Re: Investigation of Rates to be Charged by the Massachusetts Turnpike Authority for  
Wireless Providers, D.T.E. 06-70

**Investigation by the Department of Telecommunications )  
and Energy on its own motion pursuant to Chapter 123 )  
of the Acts of 2006, § 115, to establish the maximum rates ) Docket No. 06-70  
and fees to be charged by the Massachusetts Turnpike )  
Authority to wireless providers for the placement and use of )  
Wireless attachments in the central artery tunnels. )**

**DIRECT TESTIMONY OF RONALD W. BUIA, P.E.**

## Tunnel Fiber Optic Cable

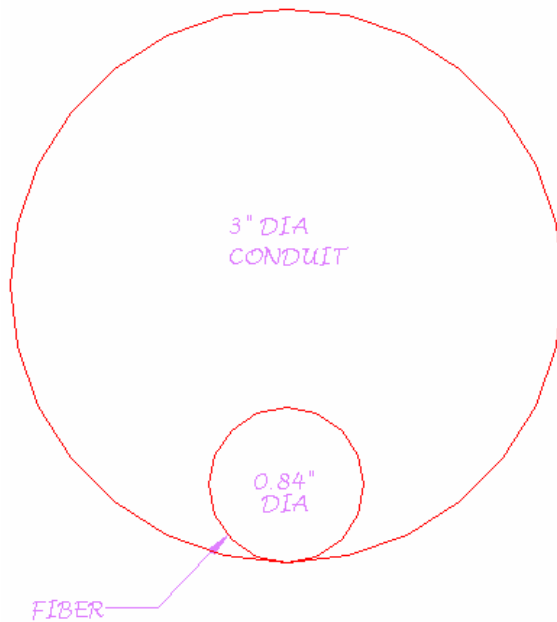
18 I have prepared a couple of diagrams to illustrate the very limited extent of the  
19 System's use of conduit, if conduit were even used in installing the System.  
20 Exhibit JC-RWB-5 is a "Conduit Detail" showing a 0.84" diameter fiber cable  
21 inside a 4" diameter conduit and setting forth the calculations that support my

1 conduit detail and the testimony above. Exhibit JC-RWB-6 shows the same thing  
2 for the 3" diameter conduit.

The fiber optic cable uses 10.93% of the allowable 40% fill space of the 3" conduit. This leaves 89.07% of the allowable cross sectional space for future cables.
